Evaluating Ring Compression Test Results for Developing Analytical Limits

Senior Reactor Systems Engineer
Office of Nuclear Reactor Research
U.S. Nuclear Regulatory Commission

Objective of Today's Discussion

- Provide an outline of possible revisions to DG-1262 and DG-1263 to ensure that the evaluation of ring compression test (RCT) results to develop analytical limits is clear, repeatable and addresses anticipated data scatter.
- Seek clarification on the alternative approaches envisioned in the comment submissions

DG-1263; Table B-5. Sample Test Matrix for Testing Prehydrated Cladding Material in the Identified Transition Region

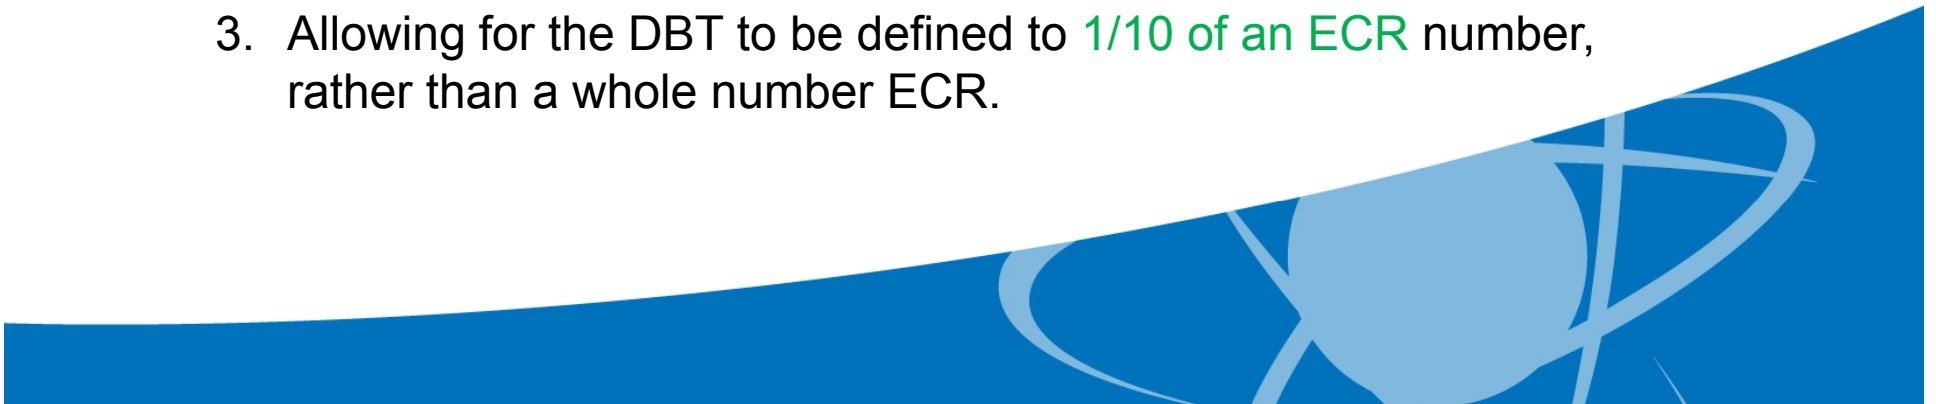
- Need to increase clarity on interpreting the outcome of a set of RCT results, sectioned from a single oxidation and quench sample, when the results include both ductile and brittle results

Approach to Conservatism

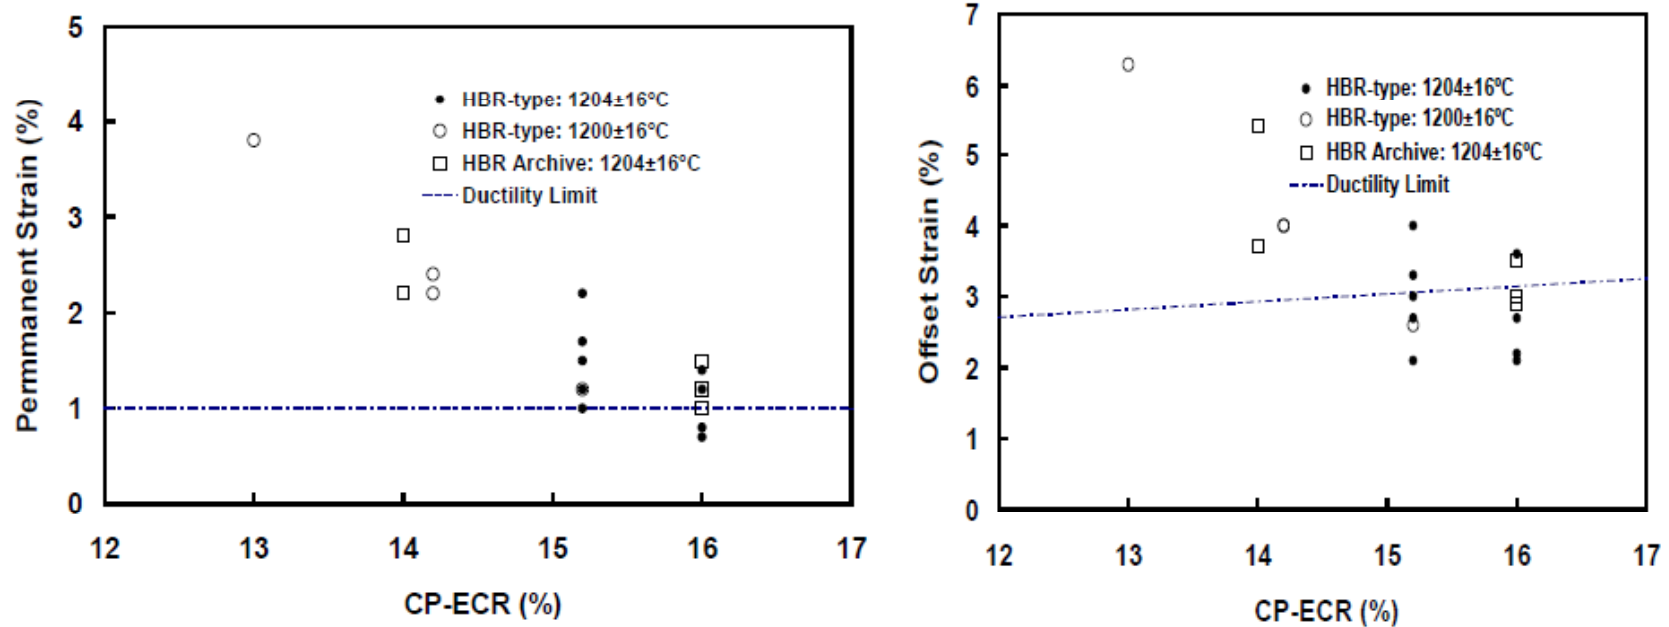
There are multiple areas where conservatism can be introduced when determining the DBT ECR value as a function of hydrogen:

1. The DBT **offset-strain criterion** is an empirical correlation that includes some conservatism
2. Rounding down to the nearest **whole number ECR** for each [H] bin provides conservatism
3. Generating a curve fit for RCT data on the strain vs. ECR plot can introduce conservatism by electing a (mean - 1σ) trend line
4. The DBT as a function of hydrogen trend line can be drawn **below** the ECR level for each [H] bin to show conservatism

ANL PQD results for 15×15 Zry-4 (HBR-type) following oxidation at 1200°C and quench at 800°C

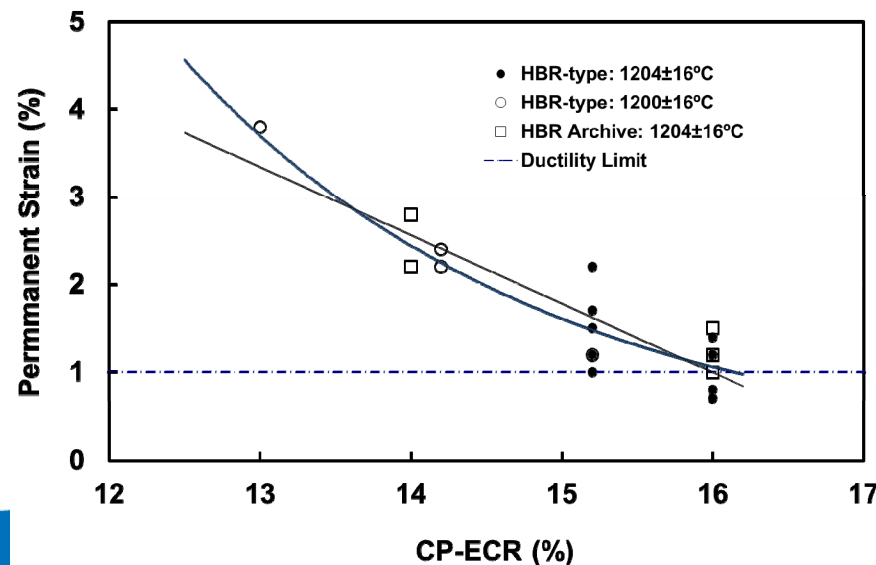
- Generate one plot that contains all RCT data for each set of results in the same [H] bin, either permanent or offset strain vs. CP-ECR

- A line can be drawn through RCT data to interpolate the DBT provided:
 - RCT data is measured above AND below the appropriate ductility criteria
 - RCT data below and above the ductility criteria resulted from tests no more than 1.0% ECR apart
 - The line is drawn through only RCT data with less than 7% offset or 5% permanent strain
 - Intersection ECR should be rounded to the nearest 0.1% ECR
 - Both linear and exponential fits could be used in this range to determine the intersection of the data trend with the ductility criterion
